## Chain tensioner

fits  
Opel 2.0l turbo and 2.2l petrol engines

**1****OLD****2****NEW**

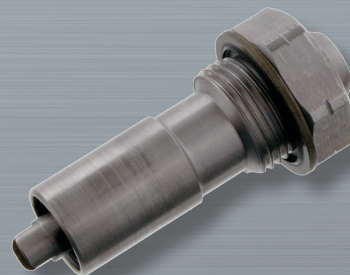
A blocked timing chain tensioner. The original version (repl. no. 0636549) of the chain tensioner had a green O-ring and a rubber-lined washer (see Fig. 1). The vehicle manufacturer fitted this version in the engines mentioned above. A modified chain tensioner has been used in production since model year 2009.

SWAG recommends using only the new chain tensioner SWAG 40 93 3044 (repl. no. 4807 839). This is provided with a rubber-lined metal washer under the head (see Fig. 2). This ensures perfect guidance of the timing chain.
